IDAP REPORT

Property:	130 Homebush Road STRATHFIELD Lot 1 in DP 170353 DA2021.168
Proposal:	Demolition of existing structures and construction of a two (2) storey dwelling house with basement level, secondary dwelling, front fence with gates, in-ground swimming pool and associated landscaping works.
Applicant:	Studio Make Made Architecture
Owner:	Y Ru and Y Gao
Date of lodgement:	23 July 2021
Notification period:	23 July to 13 August 2021
Submissions received:	Five (5) submissions
Assessment officer:	M Rivera
Estimated cost of works:	\$2,022,447.00
Zoning:	R2 – Low Density Residential - SLEP 2012
Heritage:	Adjoins a heritage item – I125 – “Cotswold” – Inter-war Californian bungalow (7-11 Cotswold Road)
Flood affected:	No
Is a Clause 4.6 Variation Proposed:	Yes – Clause 4.4C – Floor Space Ratio Variation of 7.4% (37.9m ²)
RECOMMENDATION OF OFFICER:	REFUSAL

Figure 3. Basement Plan

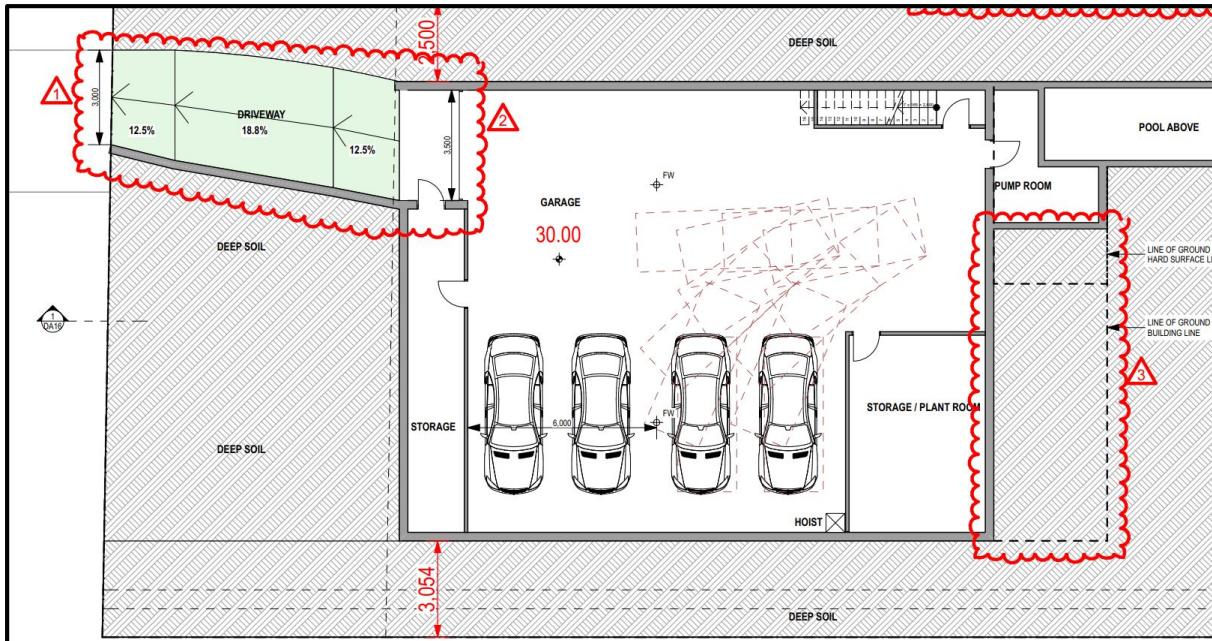
The area of non-compliance primarily relates to the two (2) additional car spaces located in the basement level.

- A bulky and excessive built form that necessitates additional excavation. The removal of additional spaces in the basement will not only result in improved compliance but further reduction to bulk and excavation. Achieving compliance provides greater opportunity to minimise the massing of the development and facilitate better modulation and articulation of the design;
- An overdevelopment of the site that is not consistent within the streetscape; and
- An undesirable precedence that reflects a disproportionate and poorly balanced design and planning outcome that fails to achieve key SLEP and zone objectives.

The proposed development mostly satisfies the relevant objectives and controls of the SCDCP 2005 in that it provides the minimum number of required parking spaces and adequate vehicular access provisions. However, it fails to meet objective G in that excavation was not kept to a minimum due to the excessive basement footprint. The basement has been kept to maximum 0.9m above natural ground level and most of it does not extend beyond the ground floor above. The only exception is the pool pump room which is beneath the alfresco area. The applicant intended for this as it is located adjacent to the pool area. This protrusion would generally be considered acceptable; however, the overall basement level is considered excessive in size and there is an opportunity to reduce the scale and footprint of the basement and situate spaces to ensure the footprint is wholly within the ground floor area. In this instance, the design of basement level, assessed as a whole, is not considered a reasonable and supportable outcome – contributing to excess bulk and scale and significant excavation.

Figure 17. Proposed void above living area

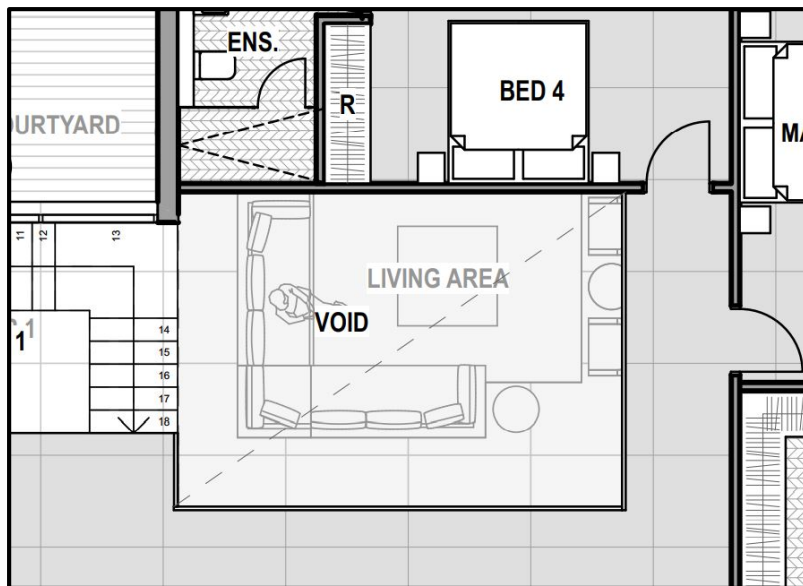
As mentioned above, the proposed development fails comply with the maximum FSR development standard under the SLEP 2012. The proposal represents an overdevelopment of the site and is considered a poorly balanced design outcome. The bulk and scale of the development is further exacerbated by the design's inclusion of a centralised void on the first floor (above the living room) (refer to Figure 17).

This void space does not provide any additional amenity for the living room (i.e. it does not facilitate additional solar access and ventilation for this space) and contributes to the excess massing of the development. This issue was highlighted to the applicant in the 'Stop the Clock' letter. It was recommended that Bedroom 4 could be re-located to the void space and the area occupied by Bedroom 4 can be deleted to provide additional setback and modulation, and thus, a reduced bulk can be achieved. In their response, the applicant confirmed that the recommendation from Council will not be incorporated into the final design.

The proposed variation to the maximum FSR development standard, combined with the provision of an unnecessary and large void space, as well as the lack of articulation and modulation of the building, ensures that the proposal is unable to satisfy the objectives and controls within the development control plan relevant to bulk, scale and FSR.
